Petitions – Stop the Coundon Cycleway, and Support the Coundon Cycleway

APPENDIX A - SCHEME DETAILS

These drawings are Post-Consultation.
The notes on the plans highlight the changes
made from the consultation drawings.

Project: Air Quality Action Plan
Coundon Cycleway

Title: General Layout Sheet 11 of 17

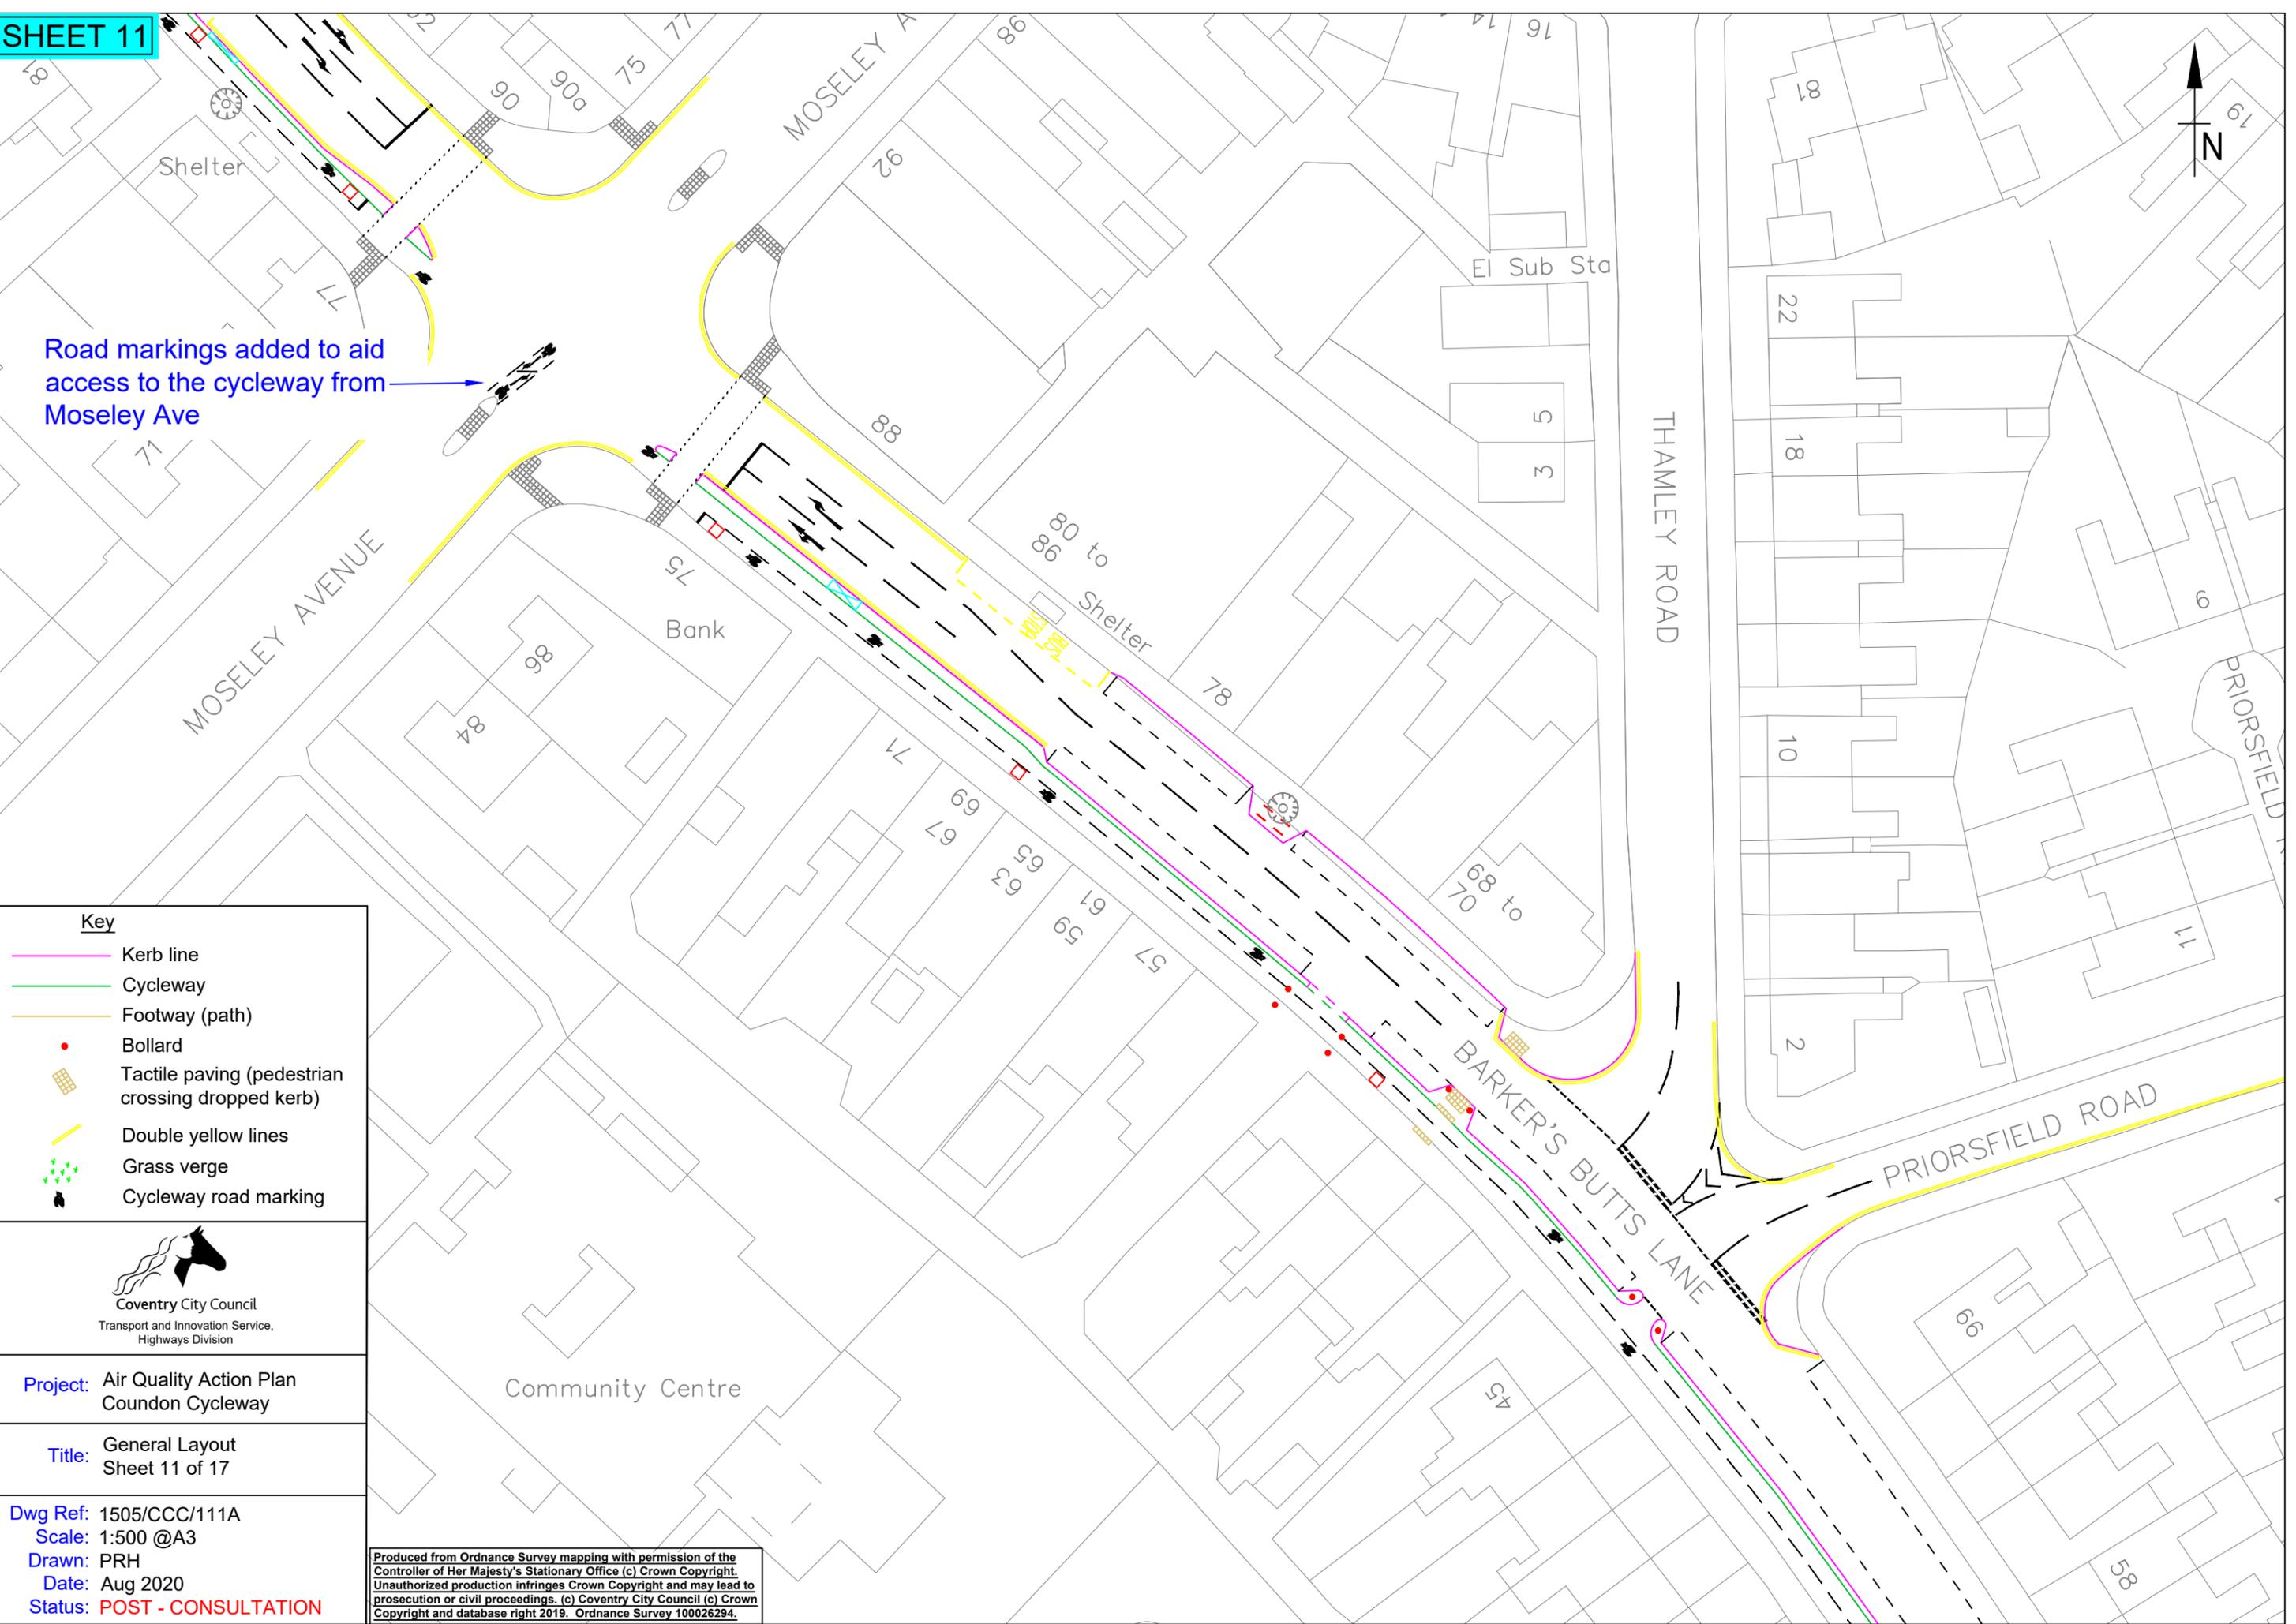
Road markings added to aid access to the cycleway from Moseley Ave

Title: General Layout
Sheet 12 of 17

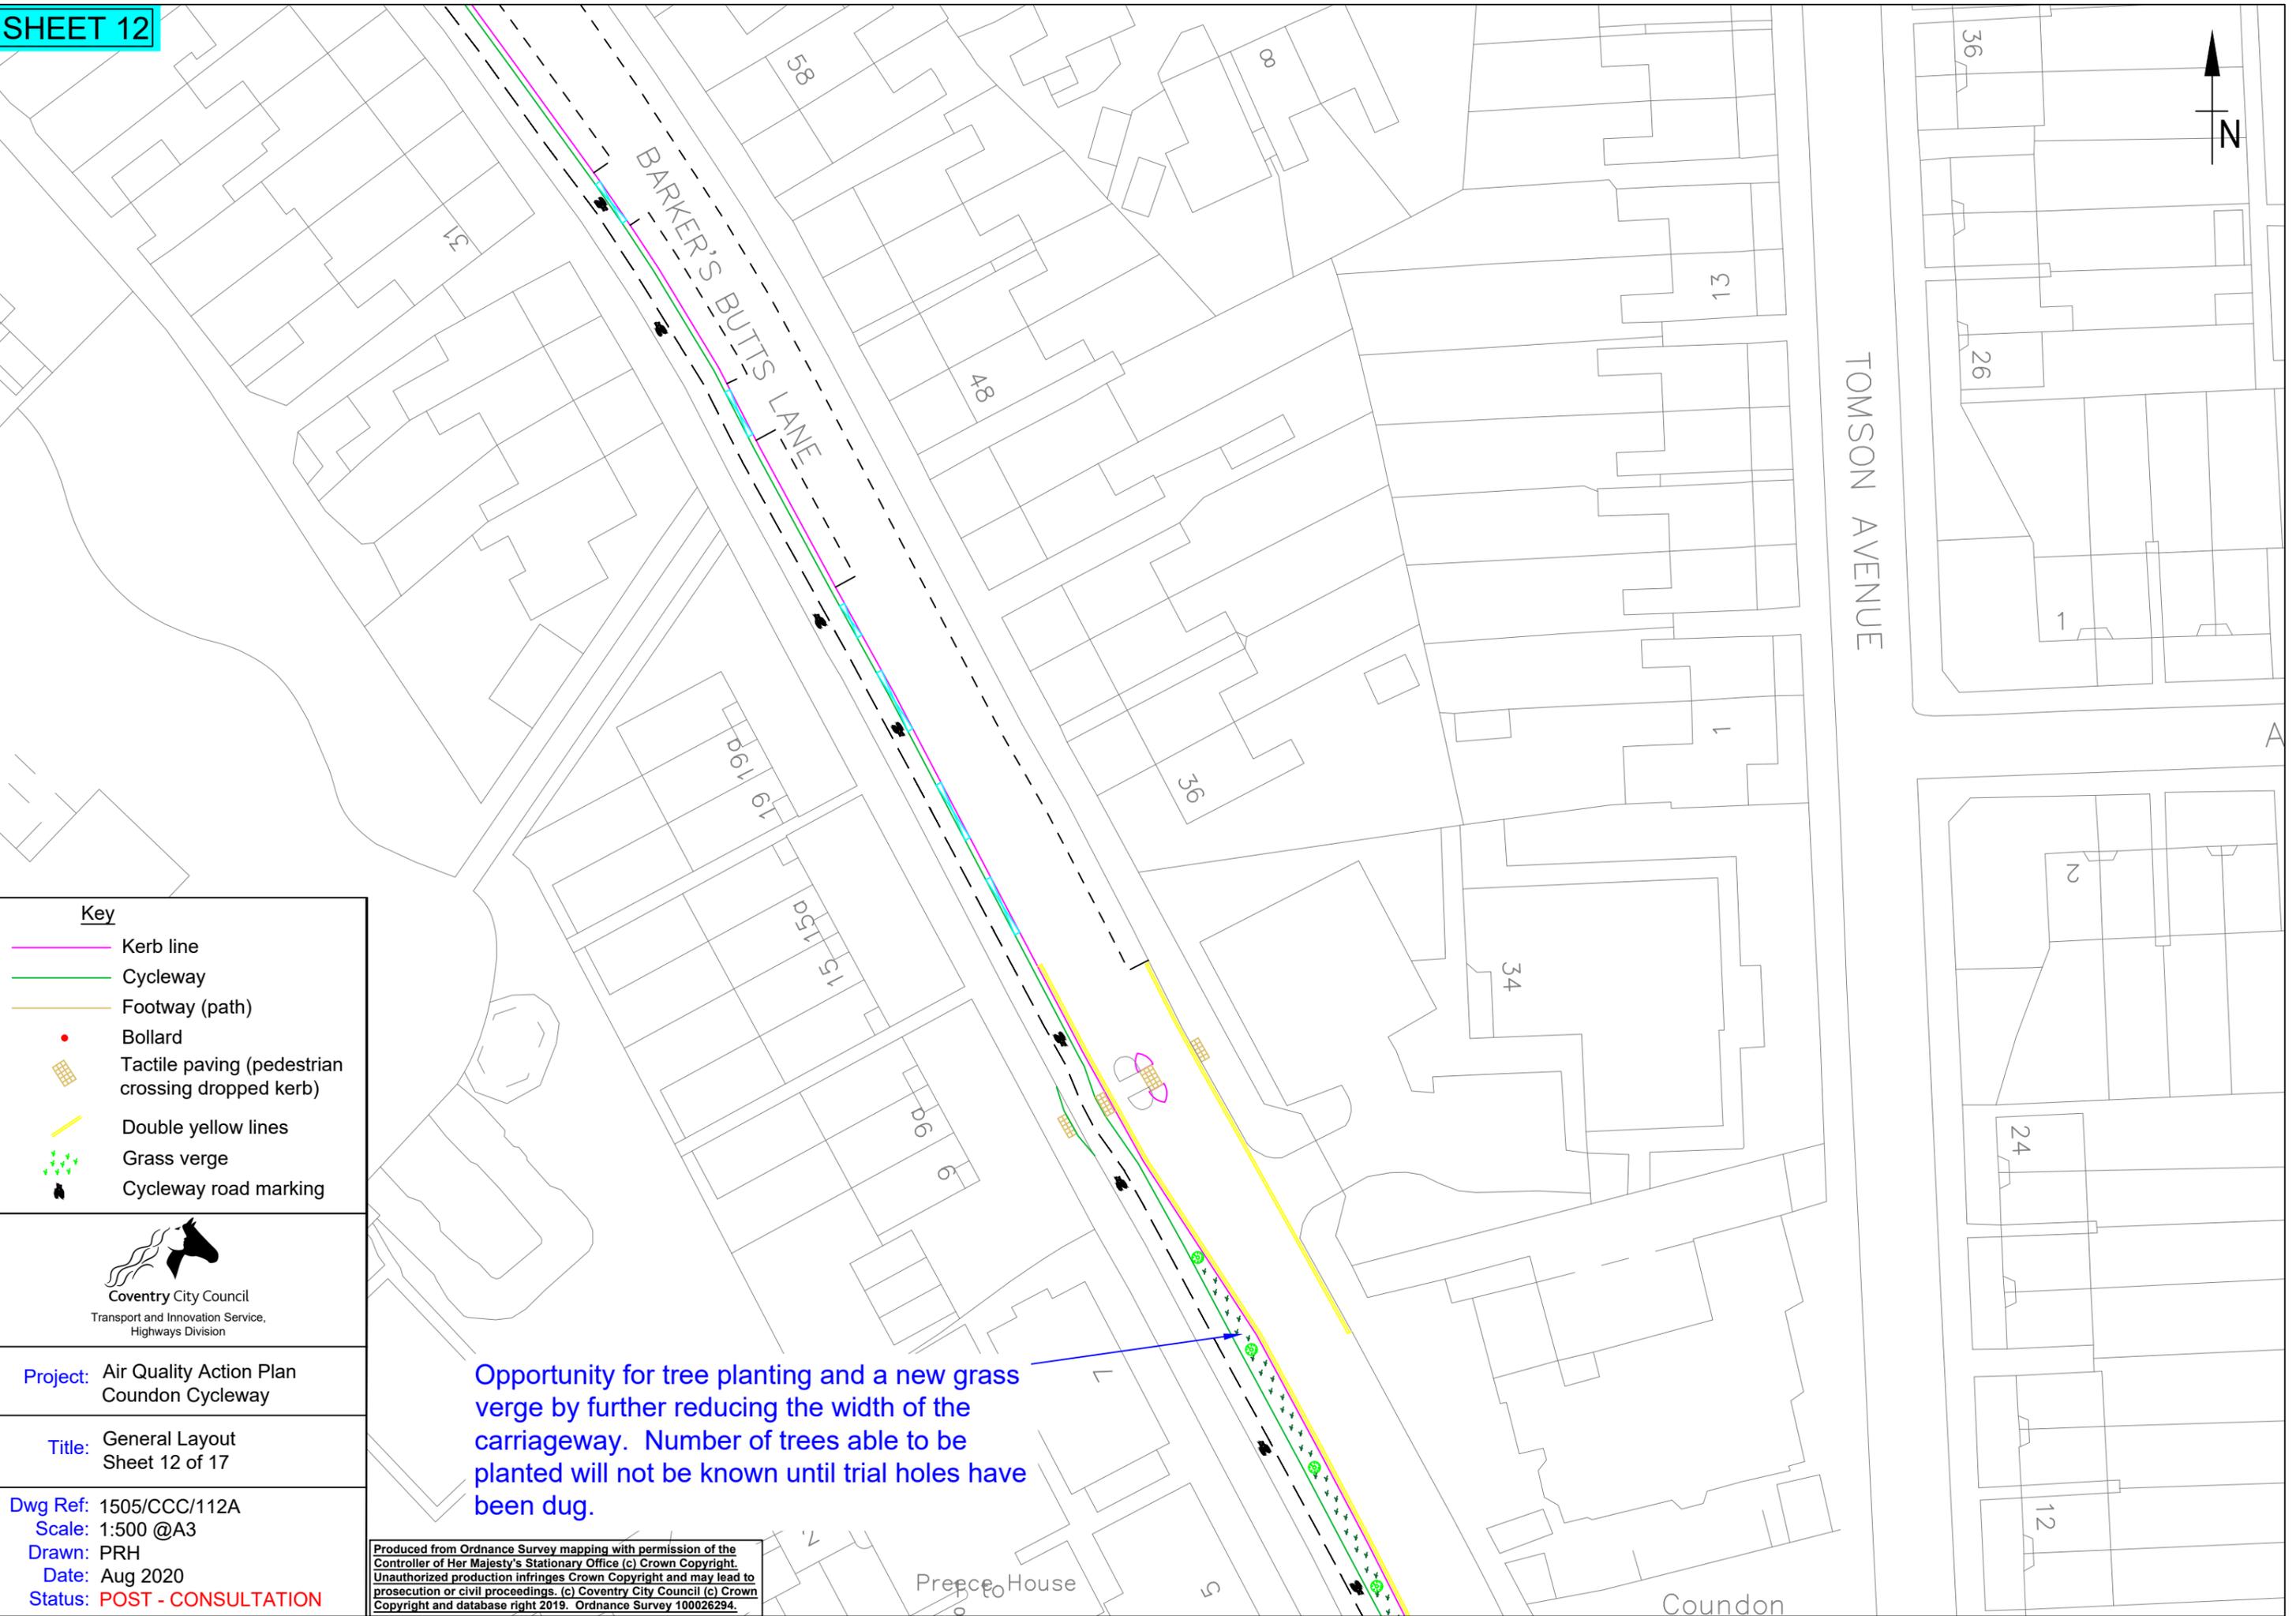
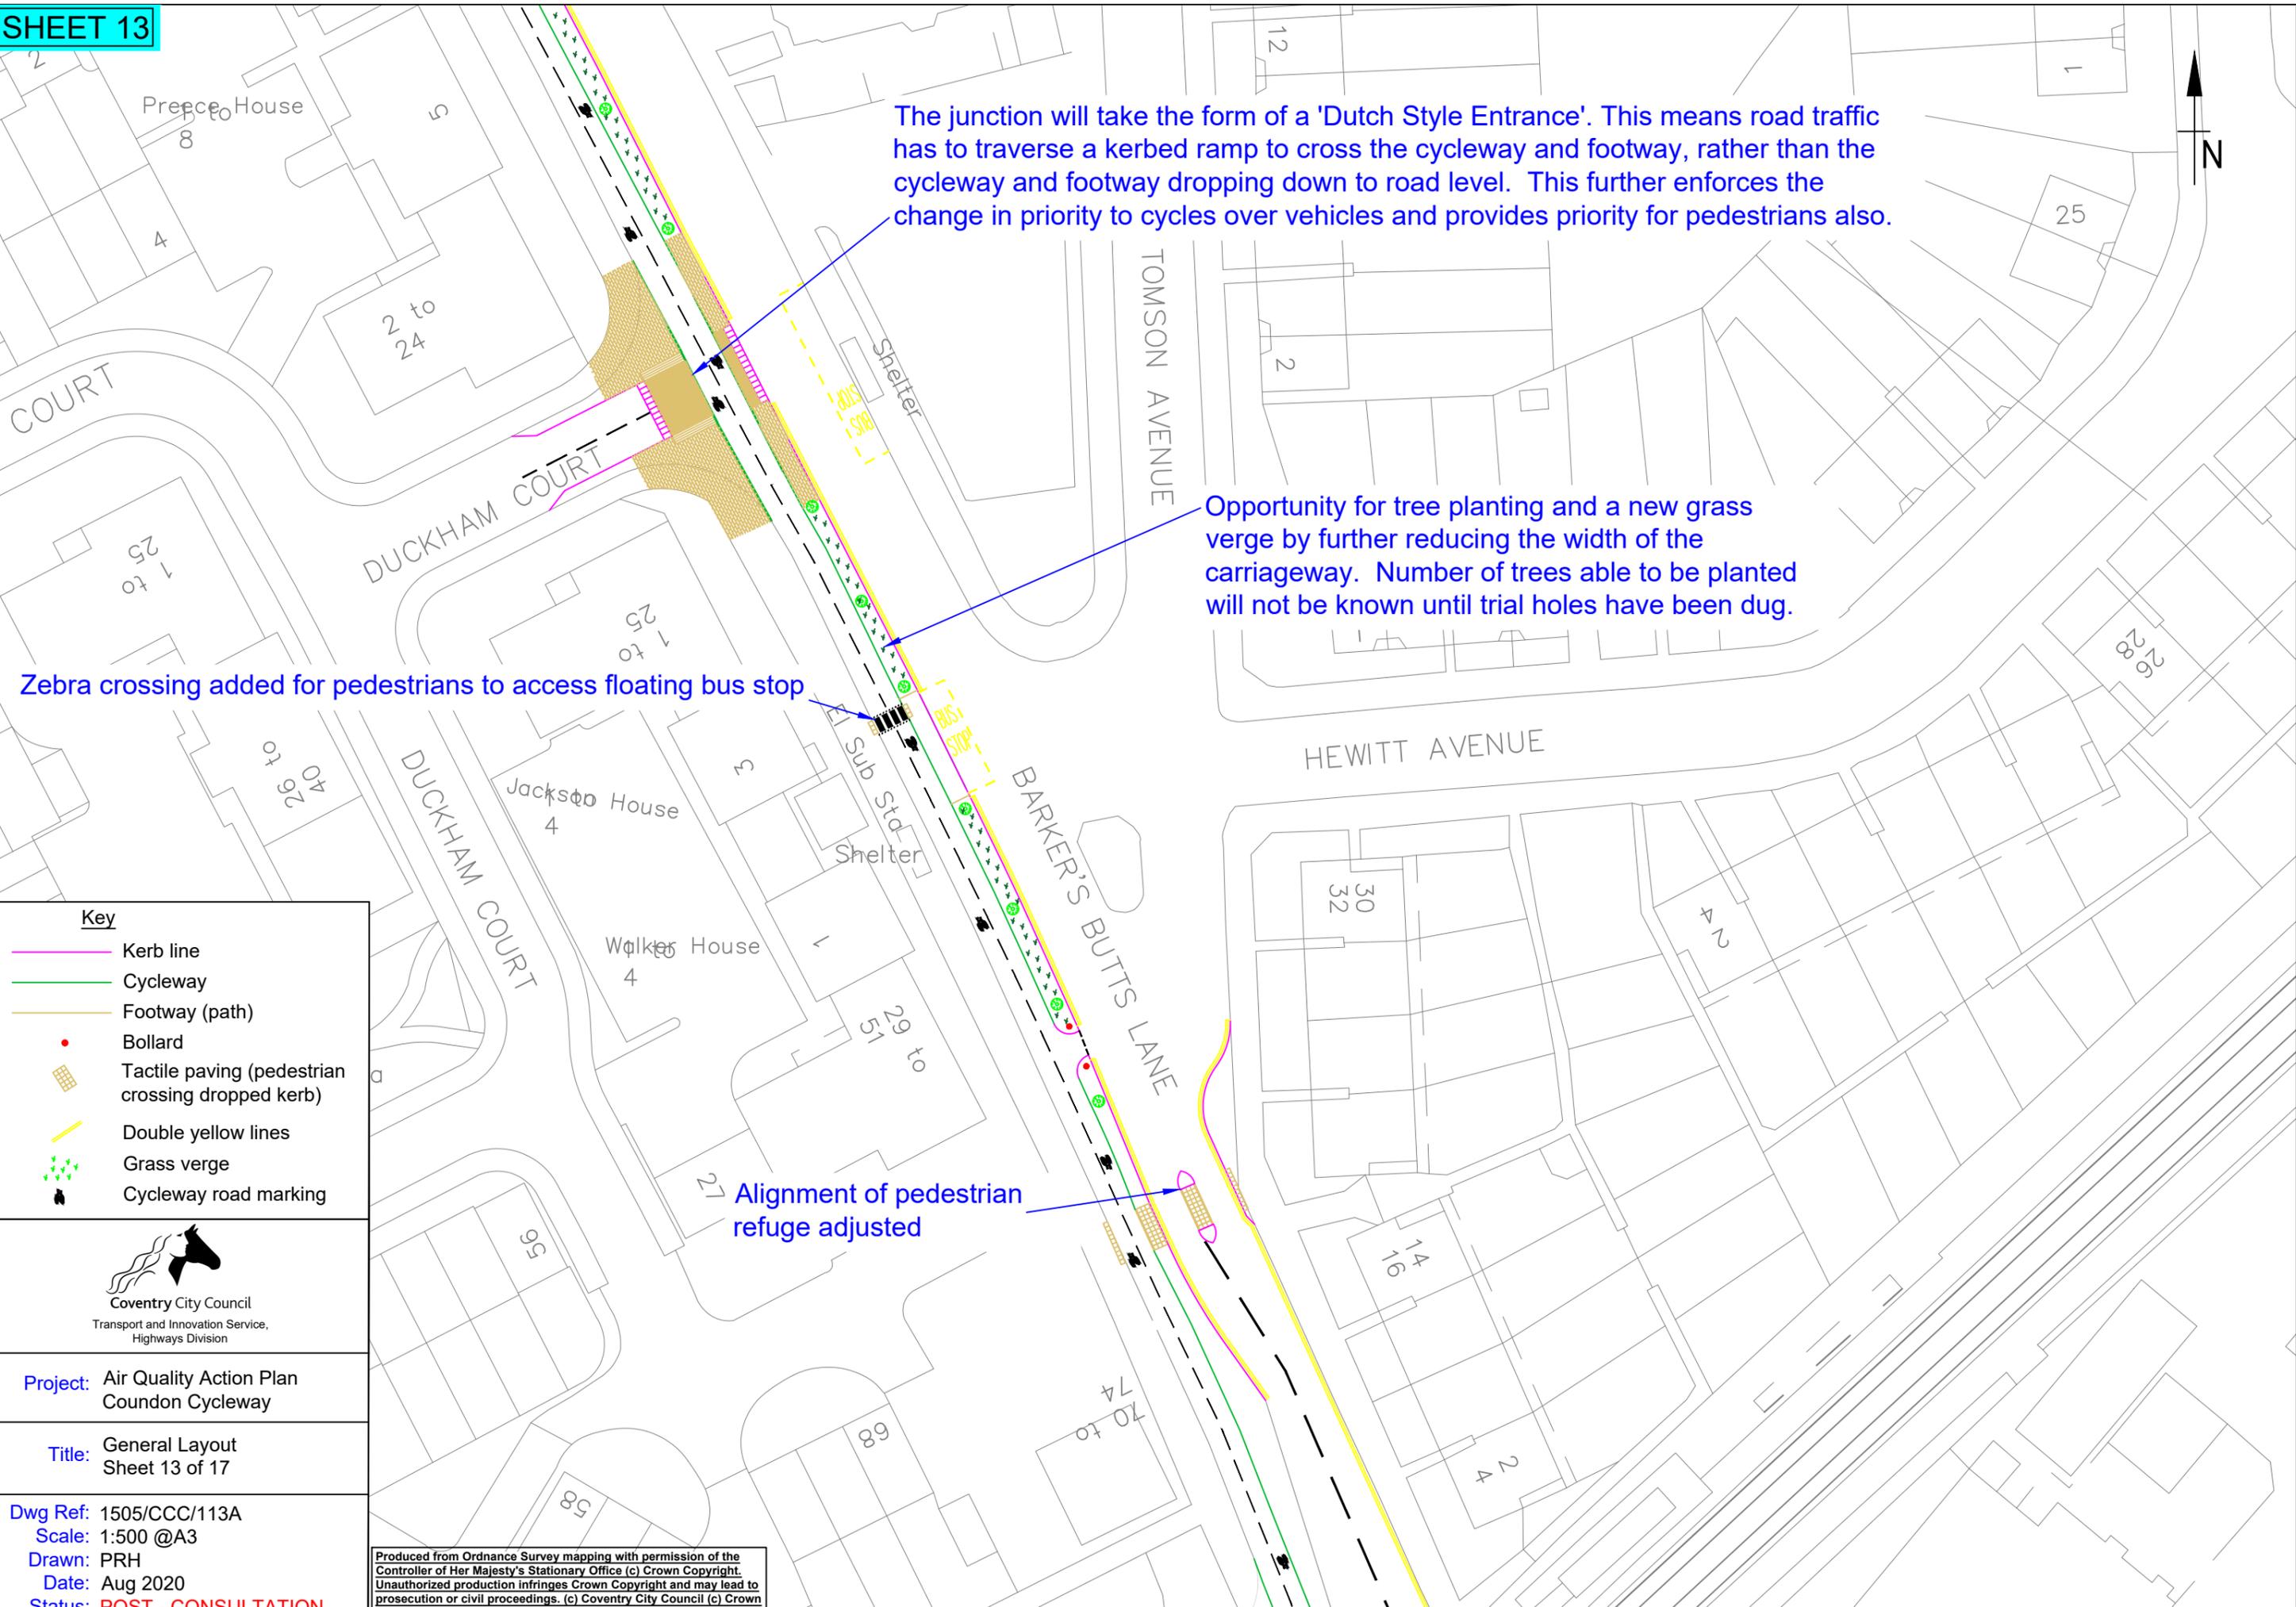
Opportunity for tree planting and a new grass verge by further reducing the width of the carriageway. Number of trees able to be planted will not be known until trial holes have been dug.

The junction will take the form of a 'Dutch Style Entrance'. This means road traffic has to traverse a kerbed ramp to cross the cycleway and footway, rather than the cycleway and footway dropping down to road level. This further enforces the change in priority to cycles over vehicles and provides priority for pedestrians also.

Opportunity for tree planting and a new grass verge by further reducing the width of the carriageway. Number of trees able to be planted will not be known until trial holes have been dug.

Zebra crossing added for pedestrians to access floating bus stop

Alignment of pedestrian refuge adjusted
